BCA COMPLIANCE REPORT

PROJECT NUMBER: 220150

PROJECT DETAILS: Queanbeyan Lot 2, 2, 18 & 31 - Rutledge St – Mixed Use Development

REPORT REVISION: 1

16. APPENDIX B – MARKED UP PLANS

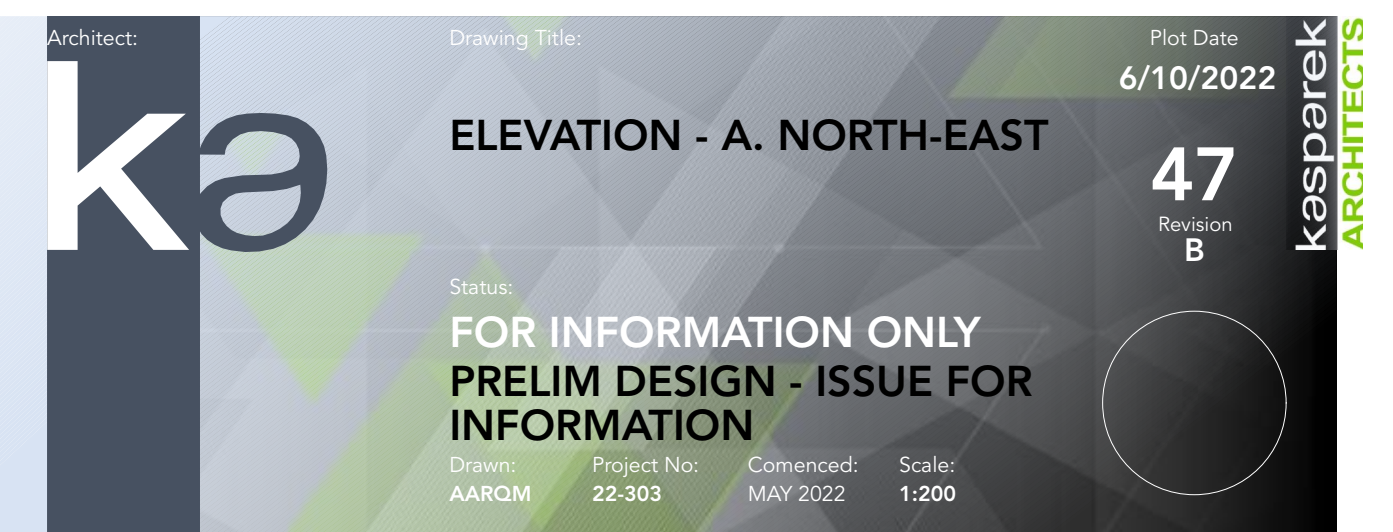
20.	BCA Clause D2D5, D2D6	<p>Current egress distances within carpark area exceed the DTS provisions:</p> <ul style="list-style-type: none"> - Basement Level -1 Distance between alternative exits is 64m in lieu of 60m. - Basement Level -2 Distance between alternative exits is 64m in lieu of 60m. <p>Note: Roller doors on basement level -1 are blocking access to the second required exit.</p>

26.	BCA Clause C3D15	The public corridors for level 1-8 on South West building and level 1-7 on North East building are more than 40m in length, therefore must be divided at intervals of not more than 40m with smoke-proof walls complying with S11C2
